### **GE-ENG-DRY-172**

#### **NRC Presentation, "Quad Cities Replacement Steam Dryer Meeting", November 8-9, 2005**

# **Quad Cities Replacement Steam Dryer Meeting**

November 8 - 9, 2005

# Summary of Strain Time Histories

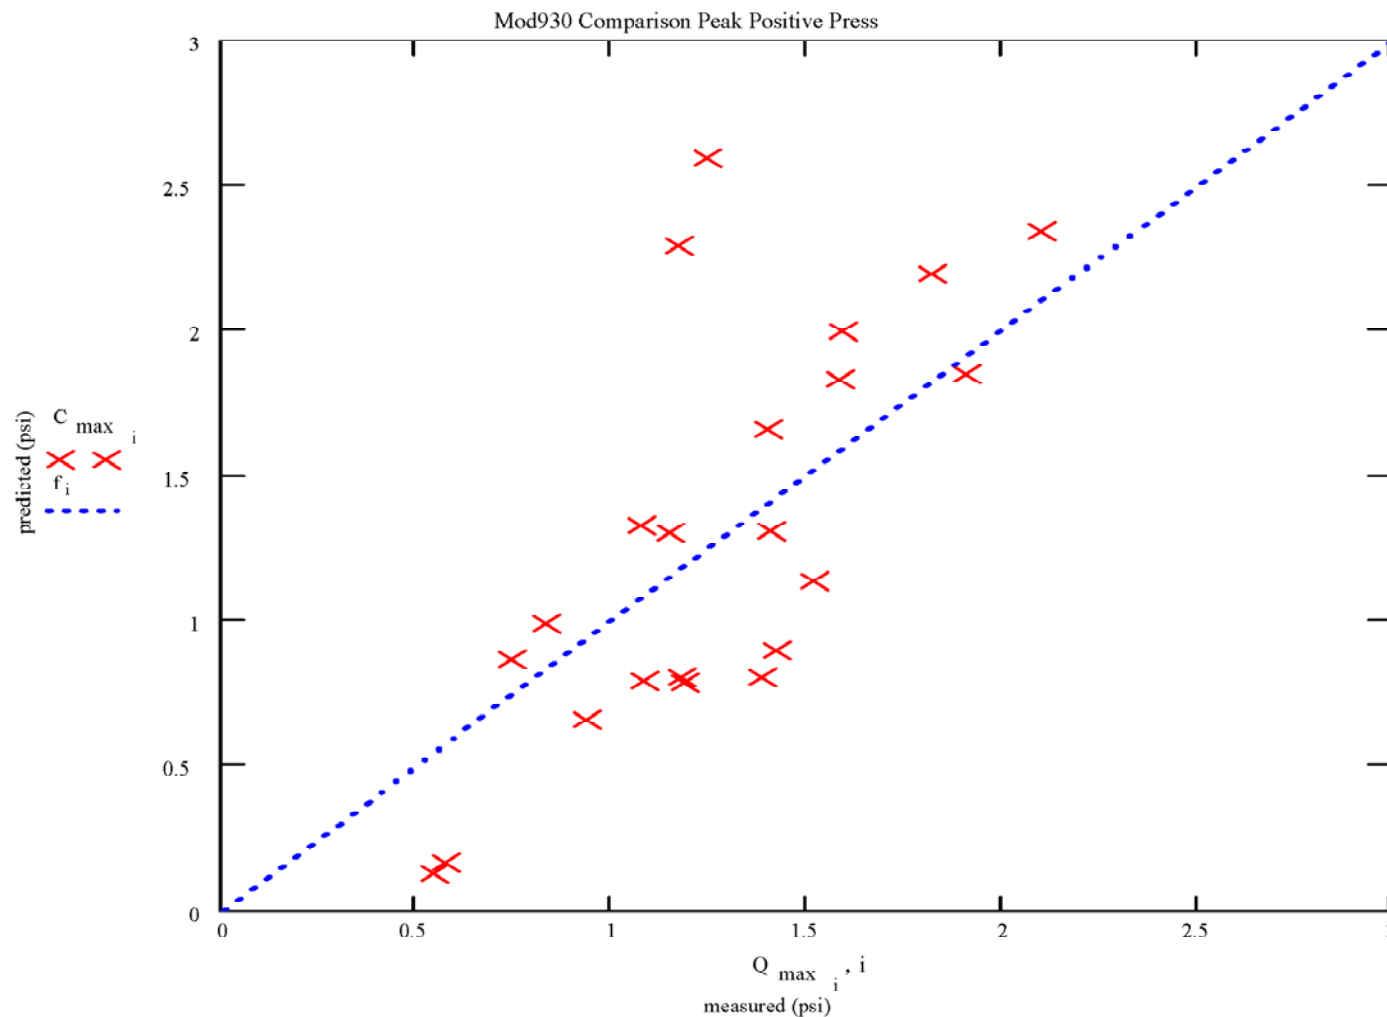
- With the exception of strain gage S-8, the strain time histories demonstrate that there is no evidence of any energy buildup effects
- The oscillations at S-8 are periodic, and the peaks grow throughout the interval; this location appears to be exhibiting energy storage and response buildup
- The strains at S-8 (skirt) are much larger than at the other locations, and the applied loads for this case are known to be conservative by a factor of at least two in RMS and peak pressure
- Peaks are distributed over the interval, and show no tendency to grow with time for strain gages S1, S5, S7, and S9

- Except for S-8, the strain time history behavior observed for all points support the hypothesis that the FEM does not show buildup and energy storage
- For the S-8 location, the applied loads are known to be overpredicted by a large margin
- Therefore, this review supports the conclusion that peak-based uncertainty is appropriate for application to this problem

RMS Comparison

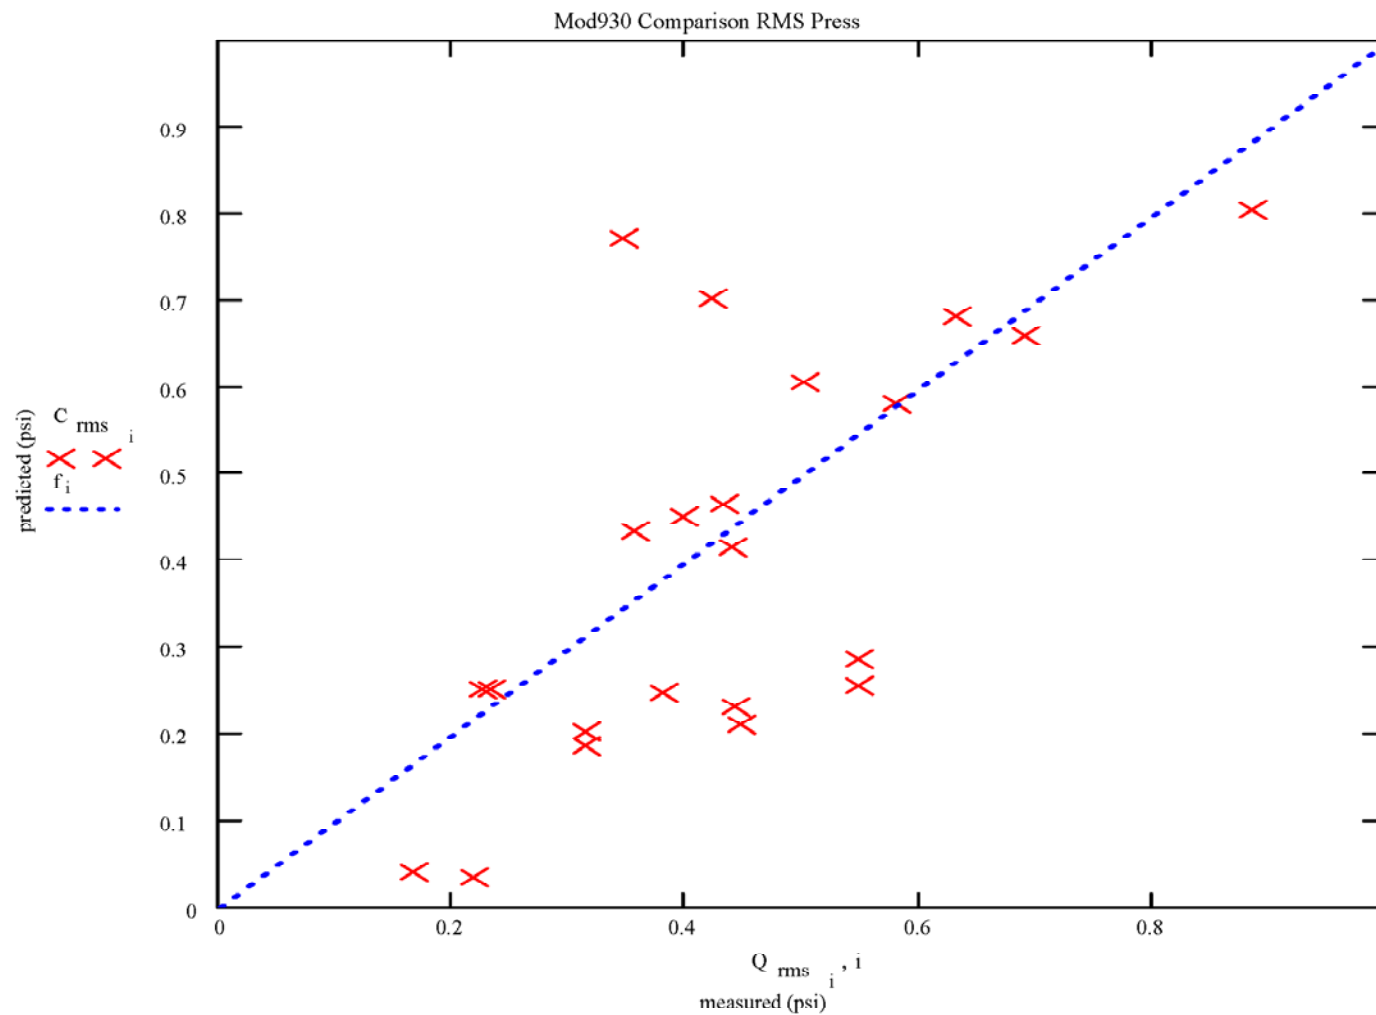
# ACM Uncertainty RMS Comparison

# Summary of Statistical Results

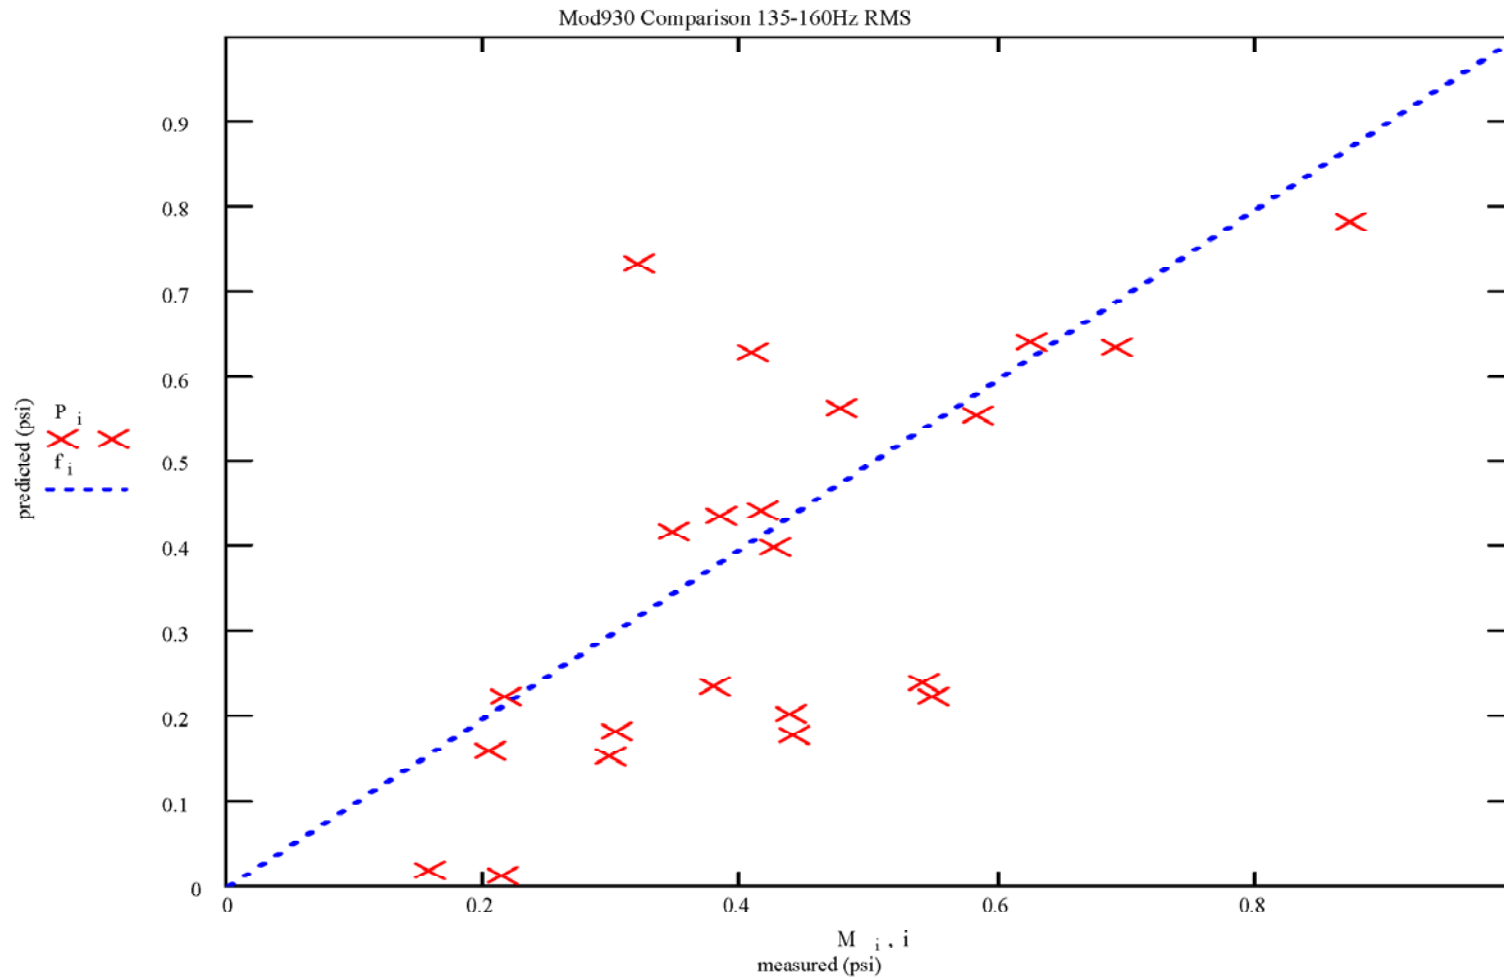
- Modified 930 MWe ACM predicts the highest RMS pressures well, with peak positive pressures and peak negative pressures showing a similar trend
- The ACM generally overpredicts the largest peak pressures while underpredicting lower pressure points
